Item Name: Bubble Window, LH

DART AEROSPACE LTD		Work Order: 146806
Description: Full Height Bubble Window, LH		Part Number: D3676-1
Inspection Dwg: D3676	Rev: D	Page 1 of 1

DESIGN	MB	DART AEROSPACE LTD HAWKESBURY, ONTARIO, CANADA	
DRAWN	DB		
CHECKED	A.P.	DRAWING NO.	REV. D
MFG. APPR.	DB	D3676	SHEET 2 OF 3
APPROVED	MB	TITLE	SCALE
DE APPR.	MB	FULL HEIGHT BUBBLE WINDOW	NTS
DATE	13.12.05	COPYRIGHT © 2012 BY DART AEROSPACE LTD THIS DOCUMENT IS PRIVATE AND CONFIDENTIAL AND IS SUPPLIED ON THE EXPRESS CONDITION THAT IT IS NOT TO BE USED FOR ANY PURPOSE OR COPIED OR COMMUNICATED TO ANY OTHER PERSON WITHOUT WRITTEN PERMISSION FROM DART AEROSPACE LTD.

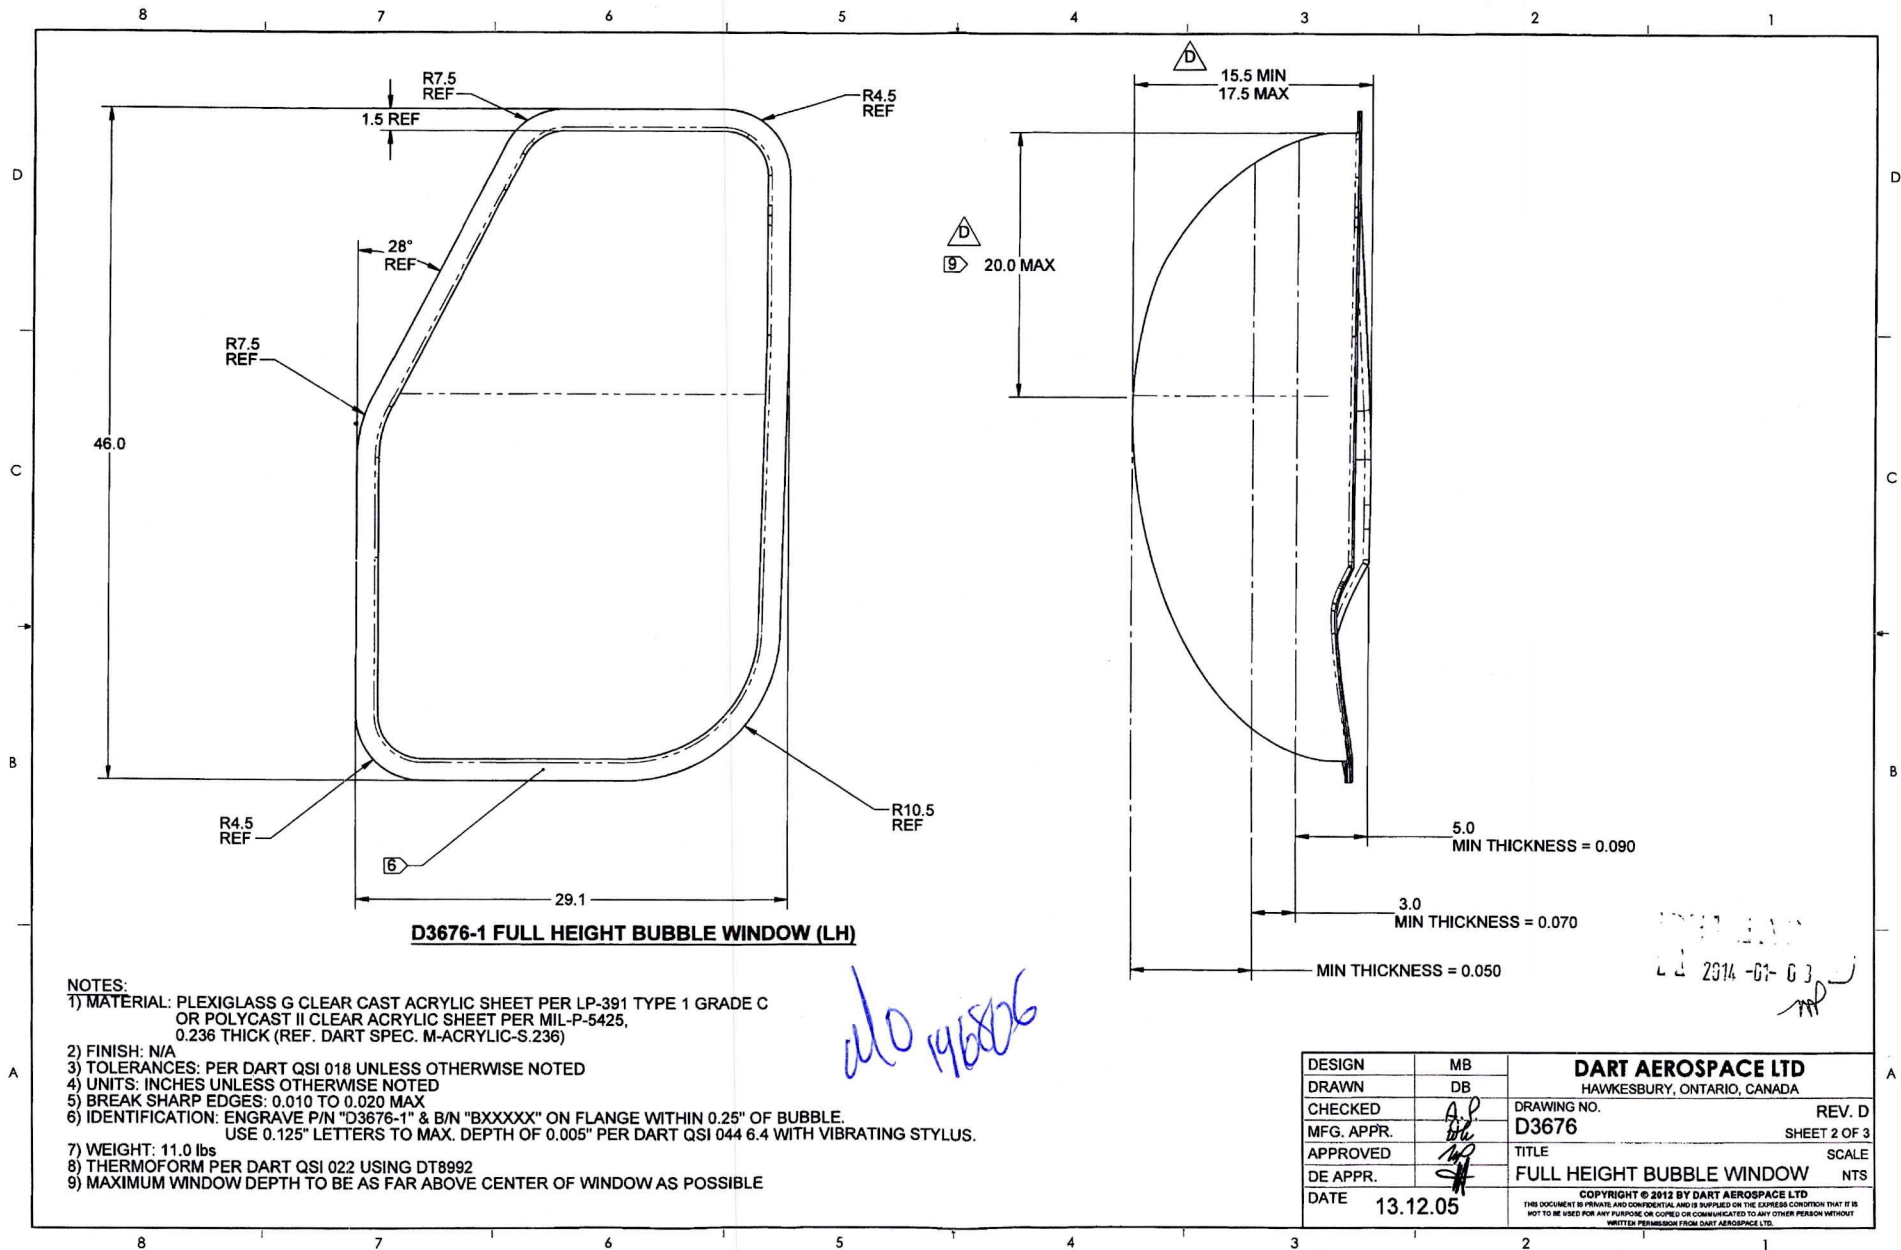
24.0 59.0 22.0 Rock of bubble is at 21" (dug=20") from top edge.				Acceptable. Depth of 20" is with dug spec, there will be no issue with clearance for pilot helmet.				INSP Completed By 12 4/16/8/26 Lead hand / Supervisor Approval Verification [Signature] 16-08-26 QC / QA Coordinator Approval DAS 9 9-89 16-08-26																																							
Root Cause		FAULT CATEGORY																																													
Environment ☐ Design ☐ Doc/Data ☐ Equip/Tooling ☐ Handling/Pre ☒ Material ☐ Internal Transport ☐ Tribal Knowledge ☐ LOA ☐ Substation ☐ Past Expiry Date ☐ Misidentified ☐	No Re-verification ☐ Operator ☐ Offset/Setup ☐ Supplier ☐ Training ☐ Use for Testing ☐ Poor Information ☐ Rushing ☐ Product Improvement ☐ Process Improvement ☐ Manufacturing Process ☐ Past Due ☐	<table style="width:100%; border: none;"> <tr> <td style="border: none;">Pressure/Forced ☐</td> <td style="border: none;">Temperature/Cure ☐</td> <td style="border: none;">Power Loss/Surge ☐</td> <td style="border: none;">Positioned Wrong ☐</td> </tr> <tr> <td style="border: none;">Bending ☐</td> <td style="border: none;">Set-up ☐</td> <td style="border: none;">Folio/Program ☐</td> <td style="border: none;">Outside Dimensions ☐</td> </tr> <tr> <td style="border: none;">Centre Not Concentric ☐</td> <td style="border: none;">BOM/Route ☐</td> <td style="border: none;">Grain ☐</td> <td style="border: none;">Over/Under tolerance ☐</td> </tr> <tr> <td style="border: none;">Cracks ☐</td> <td style="border: none;">Broken/Damage/Defect ☐</td> <td style="border: none;">Weld ☐</td> <td style="border: none;">Part Incorrect ☐</td> </tr> <tr> <td style="border: none;">Crimp/Kink/Ripple/Wave ☐</td> <td style="border: none;">Inspection Incomplete/Unqualified ☐</td> <td style="border: none;">Wrong Stock Pulled ☐</td> <td style="border: none;">Part Lost/Missing ☐</td> </tr> <tr> <td style="border: none;">Cuffs ☐</td> <td style="border: none;">Contamination ☐</td> <td style="border: none;">Out of Sequence ☐</td> <td style="border: none;">Part Moved ☐</td> </tr> <tr> <td style="border: none;">Crushing ☐</td> <td style="border: none;">Countersink ☐</td> <td style="border: none;">Off-set ☐</td> <td style="border: none;">Drawing ☐</td> </tr> <tr> <td style="border: none;">Heat Treat ☐</td> <td style="border: none;">Cut Too Short ☐</td> <td style="border: none;">Mislabeled ☐</td> <td style="border: none;">Finish ☐</td> </tr> <tr> <td style="border: none;">Wave/Twist in Tube ☐</td> <td style="border: none;">Instructions Incomplete/Unclear ☐</td> <td style="border: none;">Fit/Function ☒</td> <td style="border: none;">Misread ☐</td> </tr> <tr> <td style="border: none;">Marks/Chatter ☐</td> <td style="border: none;">Drill Holes ☐</td> <td style="border: none;">Misaligned/off center ☐</td> <td style="border: none;">Turning Sequence ☐</td> </tr> </table>						Pressure/Forced ☐	Temperature/Cure ☐	Power Loss/Surge ☐	Positioned Wrong ☐	Bending ☐	Set-up ☐	Folio/Program ☐	Outside Dimensions ☐	Centre Not Concentric ☐	BOM/Route ☐	Grain ☐	Over/Under tolerance ☐	Cracks ☐	Broken/Damage/Defect ☐	Weld ☐	Part Incorrect ☐	Crimp/Kink/Ripple/Wave ☐	Inspection Incomplete/Unqualified ☐	Wrong Stock Pulled ☐	Part Lost/Missing ☐	Cuffs ☐	Contamination ☐	Out of Sequence ☐	Part Moved ☐	Crushing ☐	Countersink ☐	Off-set ☐	Drawing ☐	Heat Treat ☐	Cut Too Short ☐	Mislabeled ☐	Finish ☐	Wave/Twist in Tube ☐	Instructions Incomplete/Unclear ☐	Fit/Function ☒	Misread ☐	Marks/Chatter ☐	Drill Holes ☐	Misaligned/off center ☐	Turning Sequence ☐

Drawing Dimension	Tolerance	Actual Dimension	Accept	Reject	Method of Inspection	Comments
0.090	Min	.173"	✓			
0.070	Min	.108"	✓			
0.050	Min	.070"	✓			
15.5 – 17.5	Min – Max	16.25"	✓			
29.1	+/-0.100	29.125"	✓			
46.0	+/-0.100	46.1"	✓			
20.0	Min	21.0"
